PREFERRED INFRASTRUCTURE REPORT

6.1 Overview

Three changes are proposed to the project described in EIS 1. These are:

Figure 6.1 Location of Epping Services Facility and Epping Decline sites

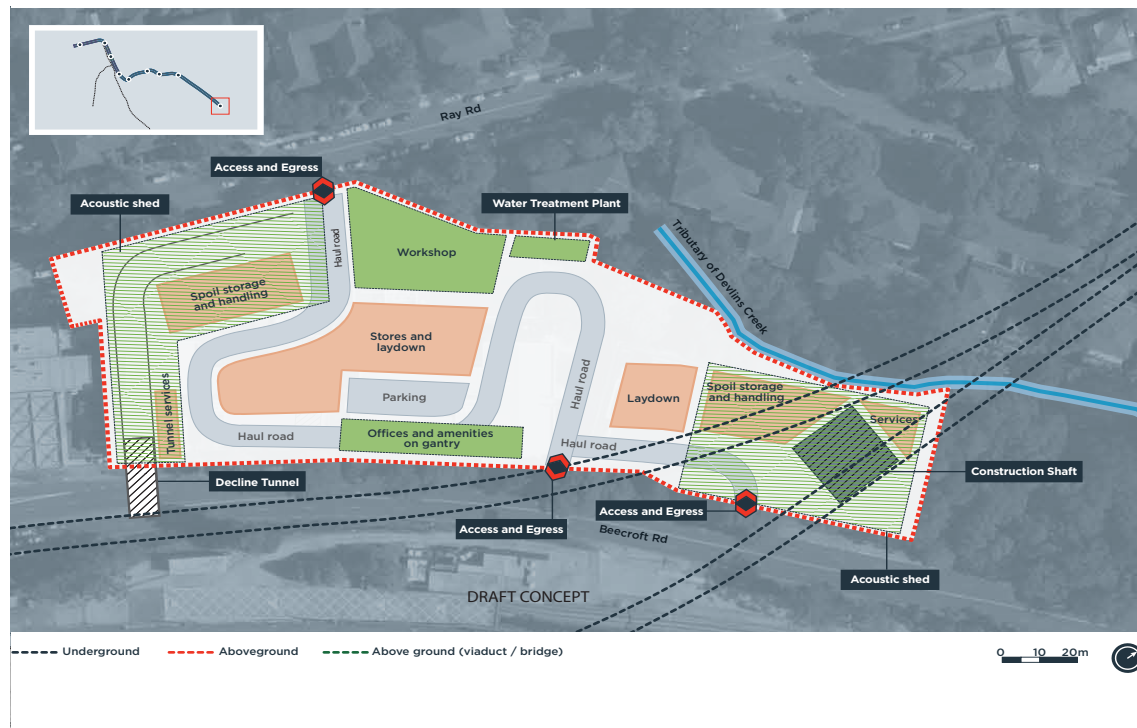
EIS 1 presented two construction sites within the Epping area, being Site 1 Epping Services Facility and Site 2 Epping Decline located on the western and eastern sides of Beecroft Road respectively. The proposed change to the project consolidates these two facilities into an expanded Site 1 and eliminates Site 2. This is shown on **Figure 6.1**.

The proposed change involves expanding Site 1 Epping Services Facility to the south-east to incorporate the full Epping Office Park site. This results in the need for three additional commercial buildings to be acquired. The expanded site would be around 12,000m² in area. This allows the

Figure 6.3 Expanded Epping Services Facility heavy vehicle routes

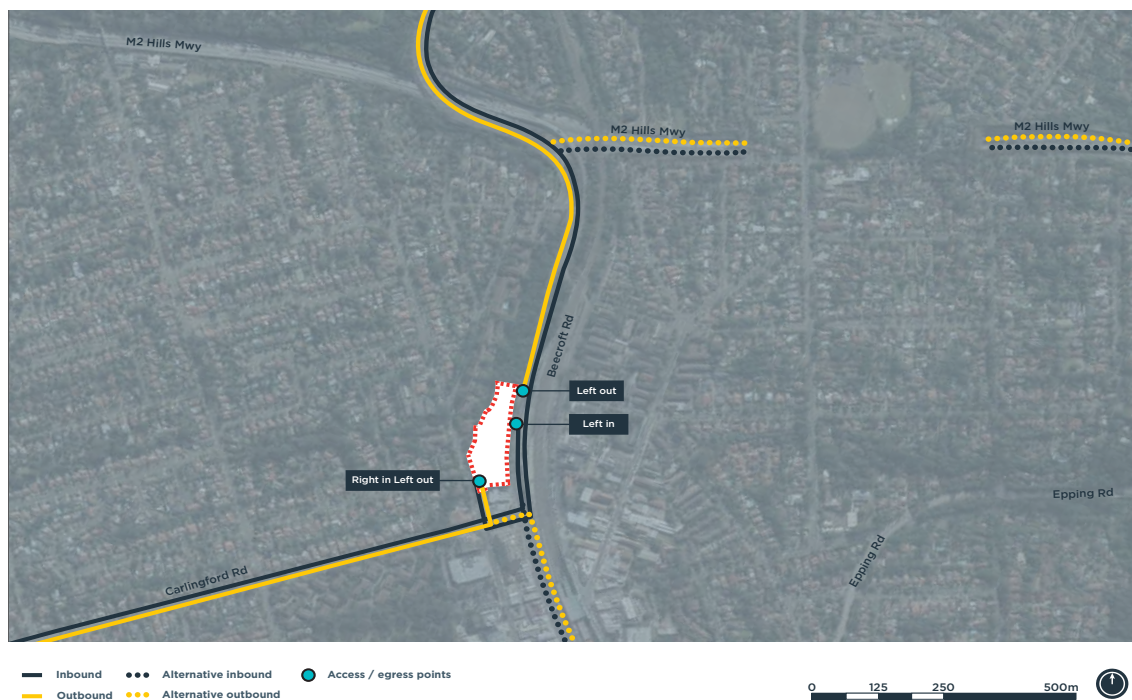
The revised construction site access routes and vehicle numbers are shown on **Figure 6.3** and provided in **Table 6.6**.

Figure 6.5 Revised noise sensitive receivers and catchment areas - Expanded Epping Services Facility

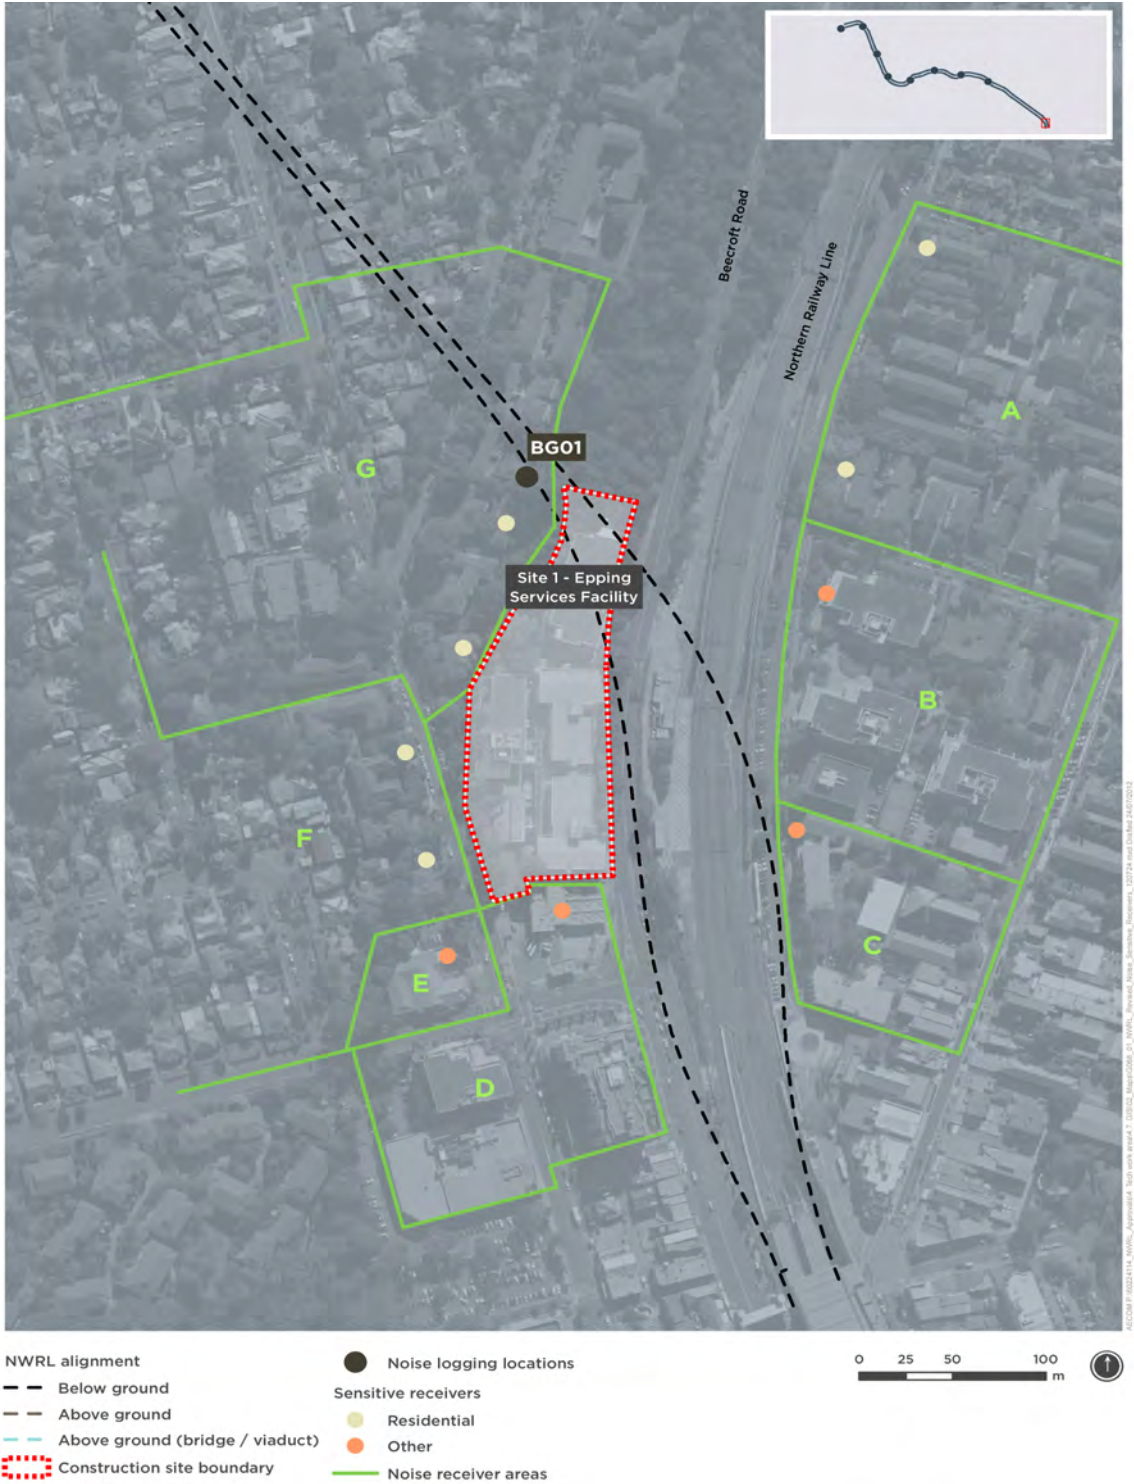
The location of sensitive receivers and noise catchment areas surrounding the Expanded Epping Service Facility site is shown on **Figure 6.5**. The revised predicted noise level exceedances are provided in **Table 6.10**.

Figure 6.11 Cheltenham Services Facility light vehicle access and egress

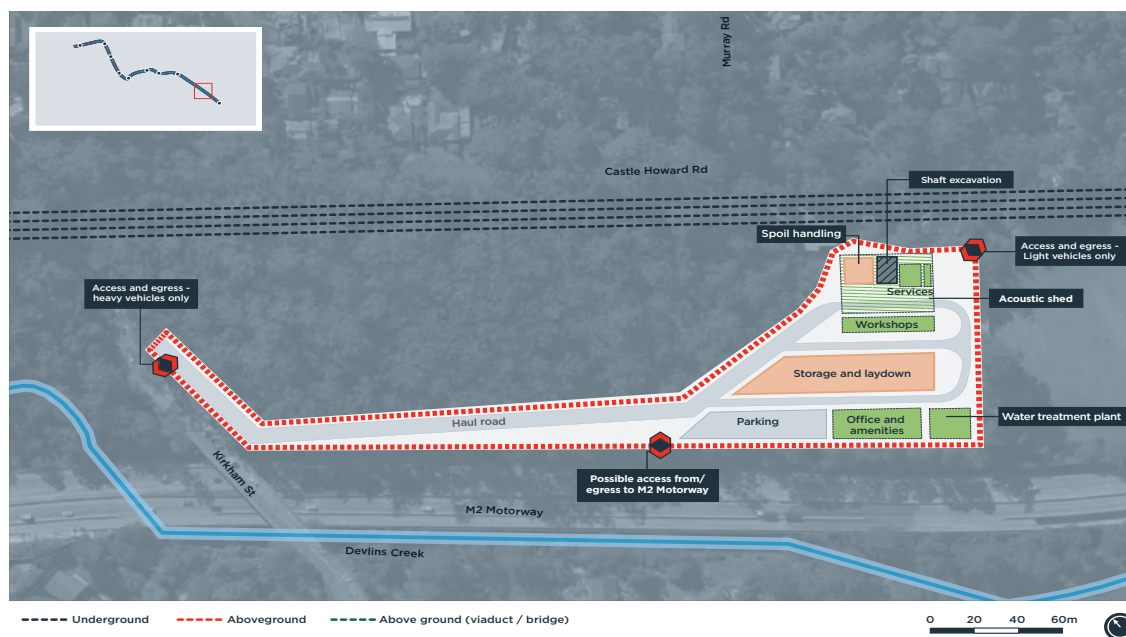
EIS 1 proposed light vehicle access and egress to and from the Cheltenham Services Facility directly on and off Castle Howard Road at the location of the road reserve for Murray Road. The proposed change relocates this access and egress point to the existing access associated with Cheltenham Oval. This is shown on **Figure 6.11**.

This proposed change reduces the total area of the Cheltenham Services Facility construction site by 2,250m² to 9,750 m² and, therefore reduces the amount of vegetation clearing required to be undertaken. There would be no changes to the construction program described in EIS 1.

Figure 6.12 Realigned Norwest Station construction site layout

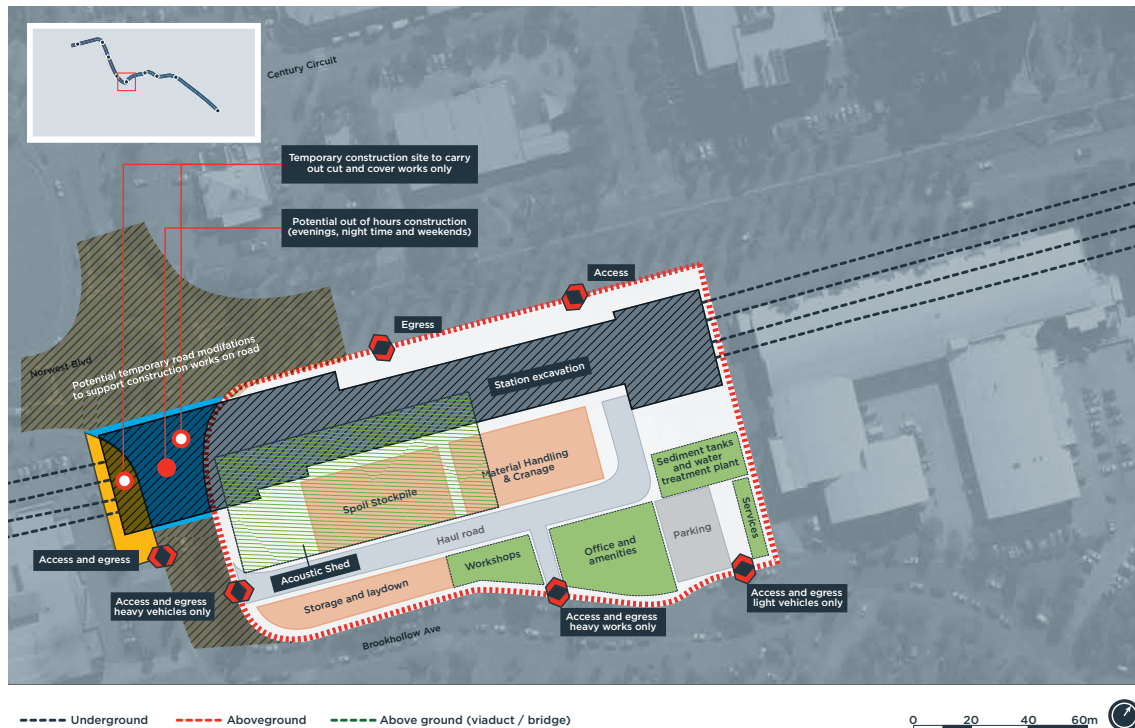
EIS 1 proposed the Norwest Station box to be located directly underneath Norwest Boulevard. The proposed change realigns the station box to the south east to be adjacent to and outside of the footprint of Norwest Boulevard. The western extremity of the box would be located beneath Brookhollow Avenue near the point where it intersects with Norwest Boulevard. This is shown on **Figure 6.12**.

However, in order to complete the excavation of the entire station box, which is up to 210m long, an additional temporary area would be required during construction. This area is shown in **Figure 6.12** and comprises an area of landscaping within the boundary of 38 Brookhollow Avenue. Temporary occupation and diversion of Brookhollow Avenue would also be required at certain times to complete the cut and cover works across this road. Alternative access would be available via the other Brookhollow Avenue / Norwest Boulevard intersection located to the north. Brookhollow Avenue would be reinstated following construction.
